Access Compliance Report

Public Rights-of-Way

(Pedestrian Signals)

Intersection ID: N/A	Main Street:	Cross Street: N/A	Location: N/A
ADA ID: 2FE4CF438C93	Signal Type: One Push Button-Non APS	Overall Compliance: No	Severity Score: BTN 1: N/A BTN 2: N/A No BTN: N/A
Codes/Mitigation Info/Possible Solution		Field Measurements/Component Compliance

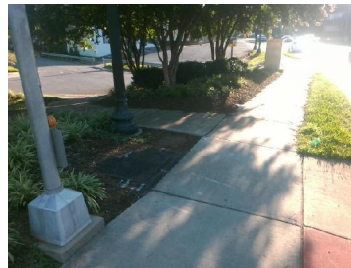
Surveyor Notes: TEXT HT 7/16

PROW/ADA: R410.6, TMUTCD 4e.08, R404.2, R406.2

Possible Solutions: Replace Signal Push Button With APS Button on New Post. Remove & Replace Sign.
